ALERT SERVICE BULLETIN

NO. 206L-01-120

SUBJECT: Tail Rotor Output Shaft 206-040-949-101 By Serial Number Recall Of.

HELICOPTERS AFFECTED: Model 206L4 helicopters with High Altitude Tail Rotor Kit, P/N 206-704-722-101, /-111, /-103.

Figure 1. Output Shaft Master Splines - Inspection

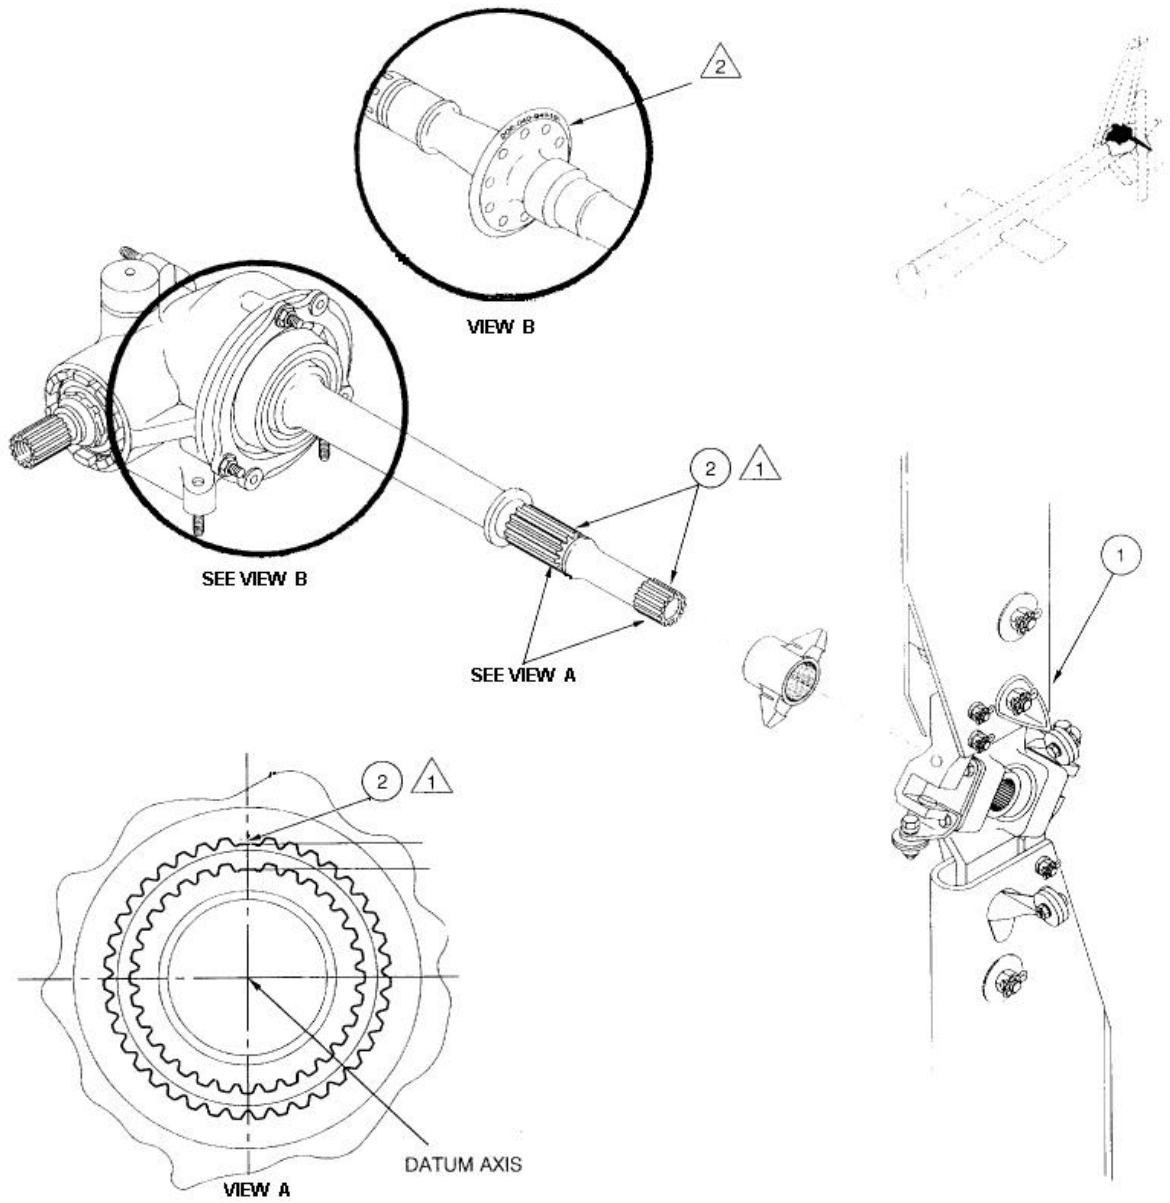
1. Upon receipt of this Bulletin check spares stock and helicopters records to identify suspected output shaft part number and serial number (Refer to Table 1)
2. If the listed output shaft is not found in your spare system or records, within the next 25 hours, proceed as follows:
 - a) Remove the tail rotor hub and blade assembly (1, Figure 1) (BHT-206-SI-2054 or BHT-206-SI-2057).
 - b) Examine shaft splined area to make sure that both master splines (2) are aligned.
3. If master splines are not aligned, remove the tail rotor gearbox output shaft cover and check for output shaft part number and serial number (BHT-206-SI-2054 or BHT-206-SI-2057). To locate part number and serial number, refer to Figure 1.

4. If the output shafts master splines are not aligned and/or the part number and serial number match the number in Table 1. Remove the shaft from service and contact Bell Helicopter Product Support Engineering

5. If the output shaft master splines are aligned no further action is required. Install tail rotor hub and blade assembly (BHT-206-SI-2054 or BHT-206-SI-2057).
